Comments: 12/23/2020

T R A F F I C I M P A C T S T U D Y

Porteos Distribution Facility (Lot 10B)

Aurora, Colorado

PORTEOS DISTRIBUTION FACILITY
AURORA, CO
PROJECT TRIP DISTRIBUTION

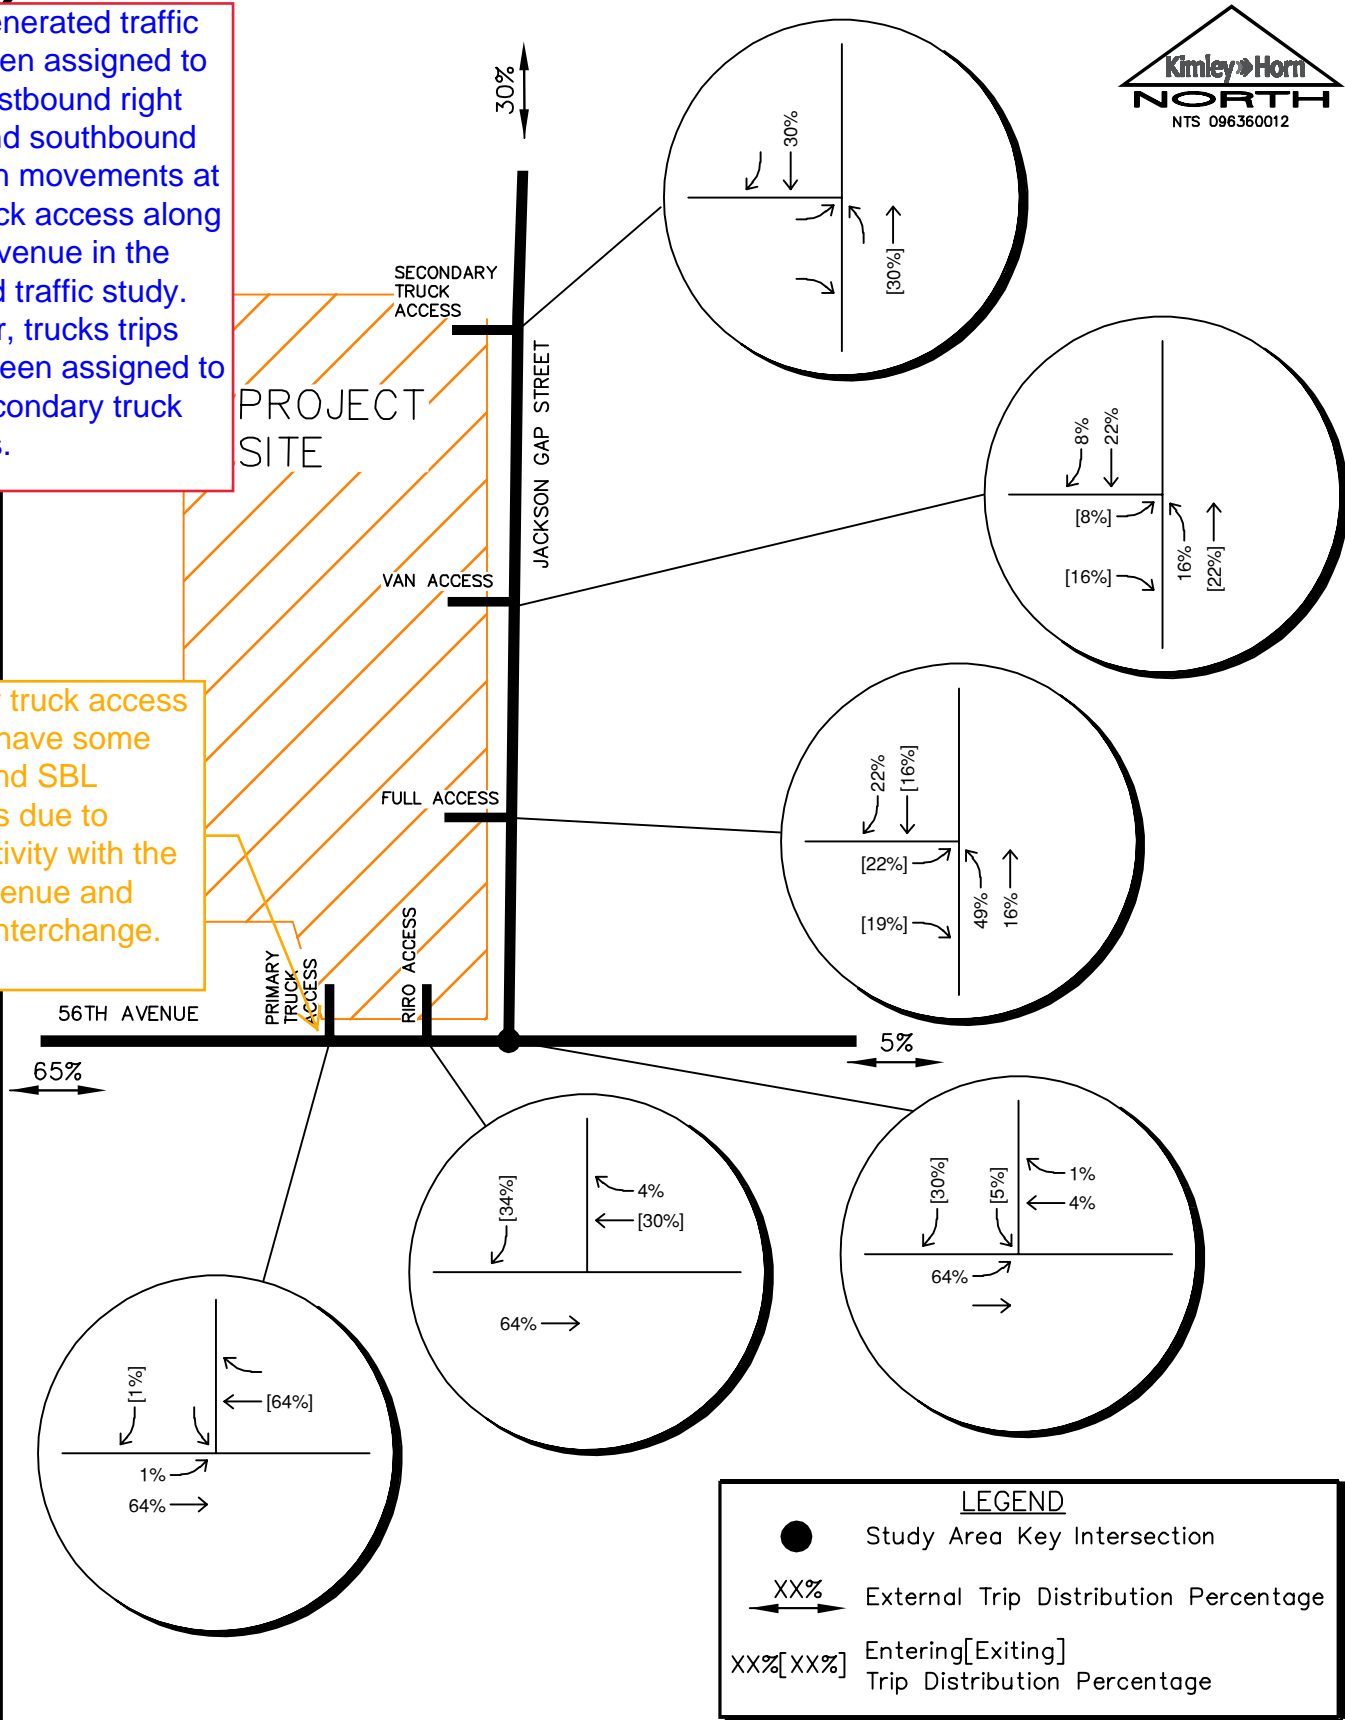
Explain why the secondary truck access has no volumes assigned to it.

Primary truck access should have some WBR and SBL volumes due to connectivity with the 64th Avenue and E-470 interchange.

As a more refined user specific data was obtained, overall trips have since decreased; however, truck trips during the peak hours has increased. As such, trucks have been assigned to the secondary truck access in the revised traffic study.

Site generated traffic has been assigned to the westbound right turn and southbound left turn movements at the truck access along 56th Avenue in the revised traffic study. Further, trucks trips have been assigned to the secondary truck access.

PORTEOS DISTRIBUTION FACILITY
AURORA, CO
2023 BACKGROUND
PLUS PROJECT TRAFFIC VOLUMES

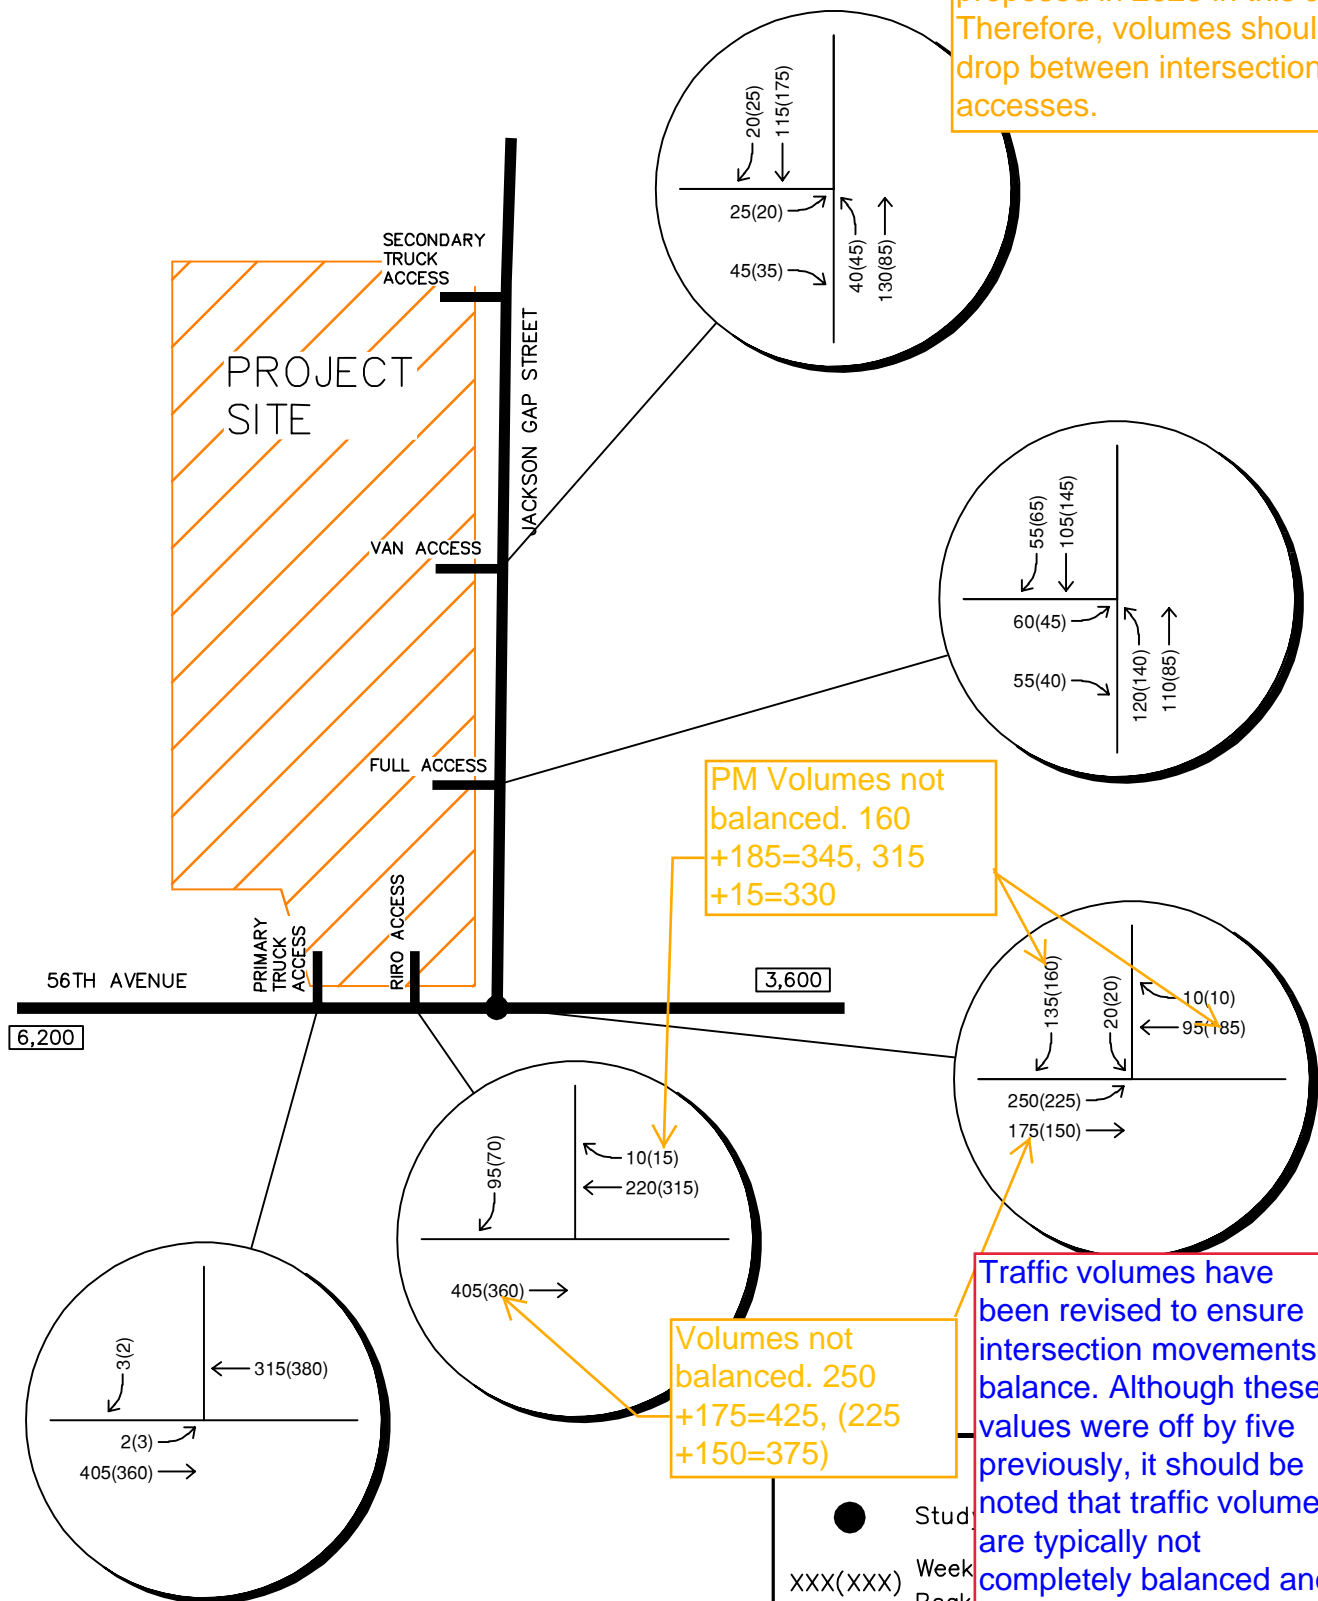
Check continuation of traffic movements. No other developments or accesses are proposed in 2023 in this area. Therefore, volumes should not drop between intersections/ accesses.

PM Volumes not balanced. 160 +185=345, 315 +15=330

Volumes not balanced. 250 +175=425, (225 +150=375)

Traffic volumes have been revised to ensure intersection movements balance. Although these values were off by five previously, it should be noted that traffic volumes are typically not completely balanced and sometimes differ by five due to calculations rounding to intervals of five.

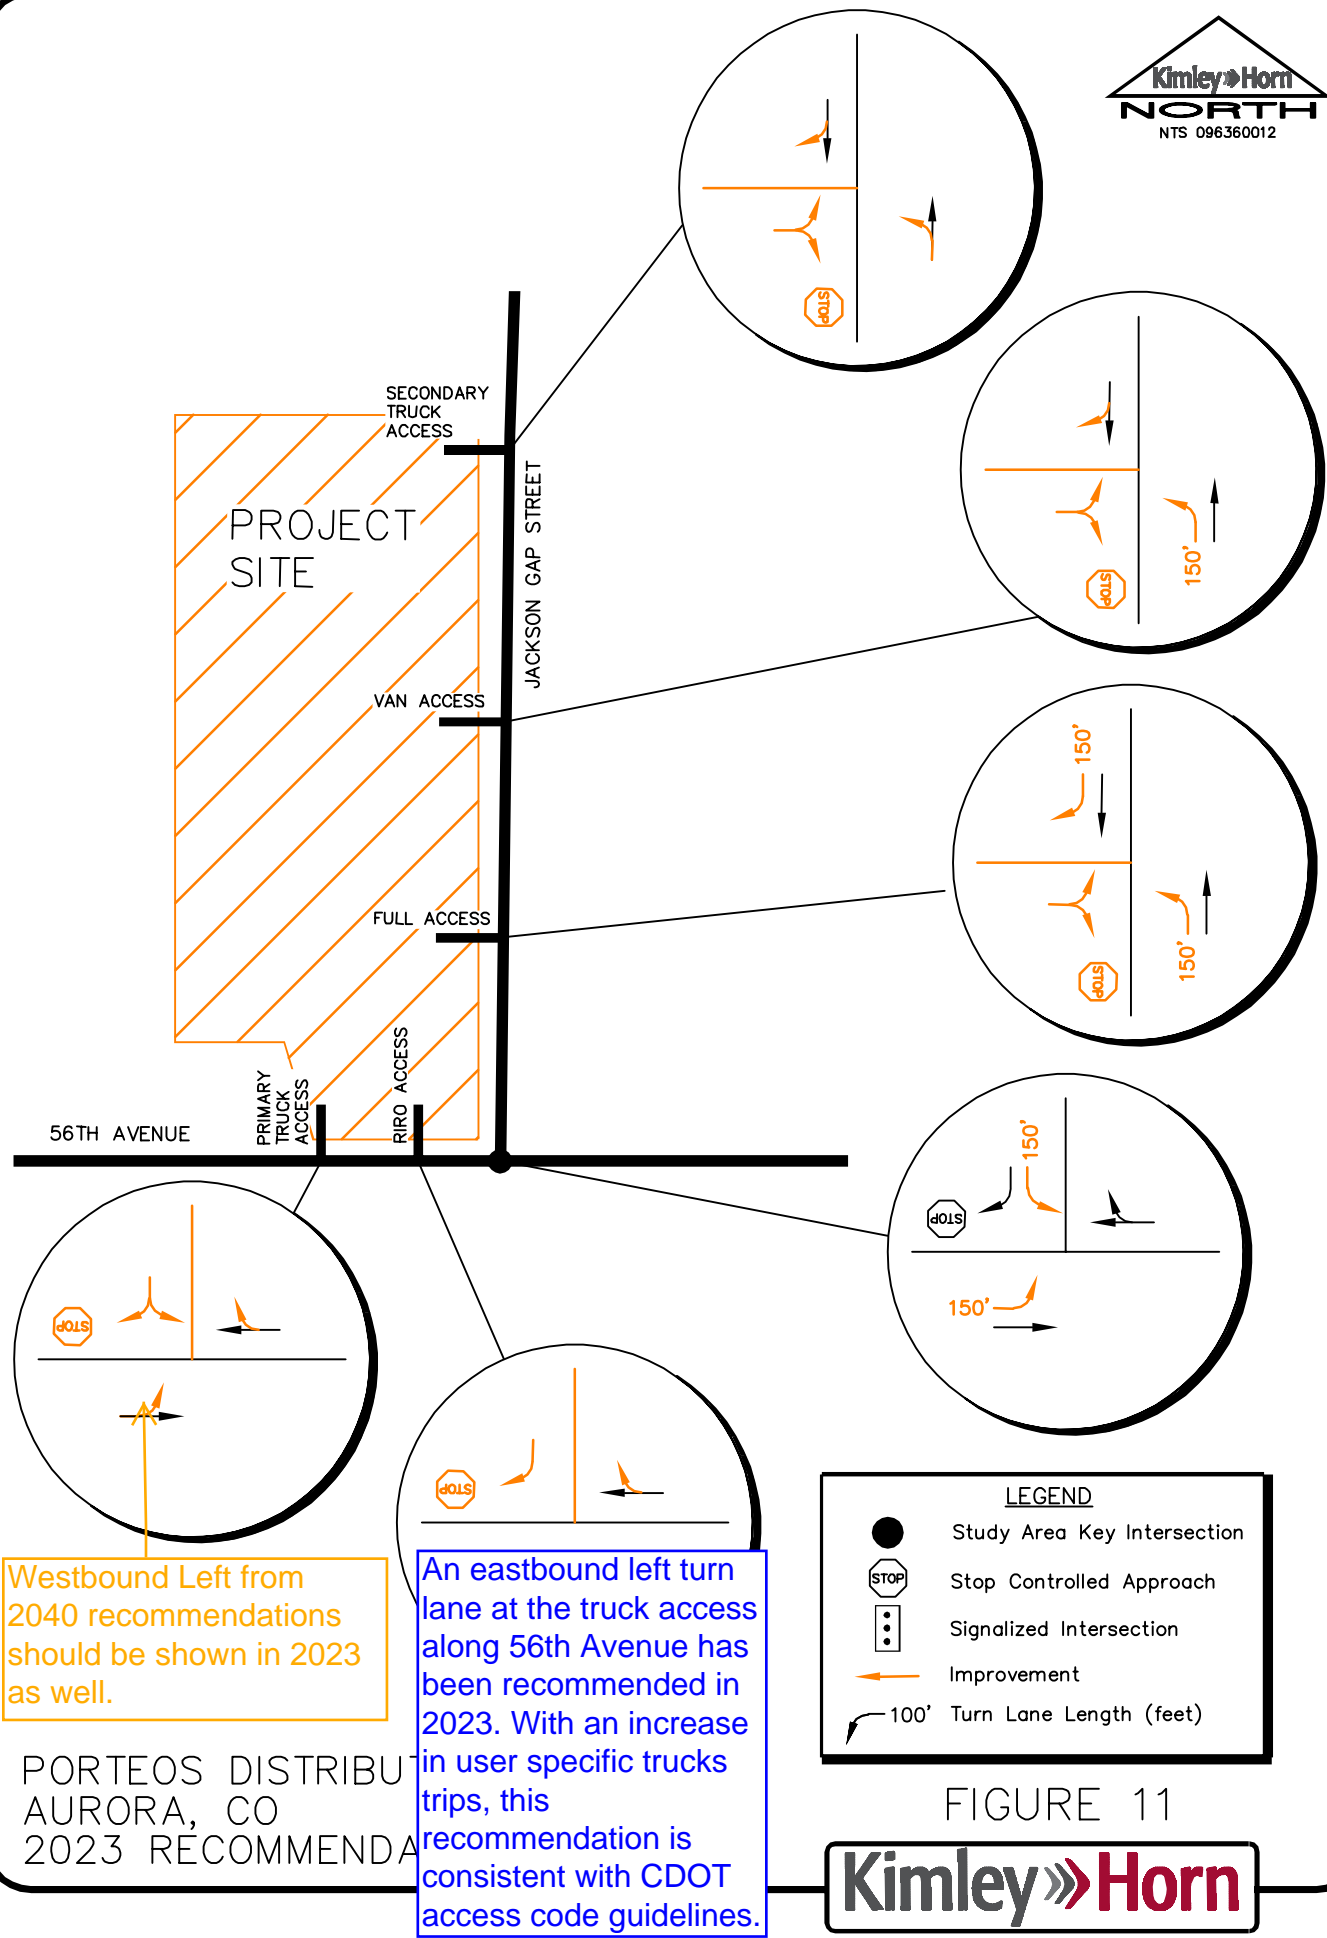
Although the calculations suggest that only 1 van length is required for storage, the likelihood of the holding true at all times is extremely low at 66 veh/sec. Please provide additional discussion/analysis.

As current user specific traffic generation has been obtained, the entering volumes for the vans is currently 15 vehicles per hour. It has been recommended that the van access provide space for two vehicles to queue on site.
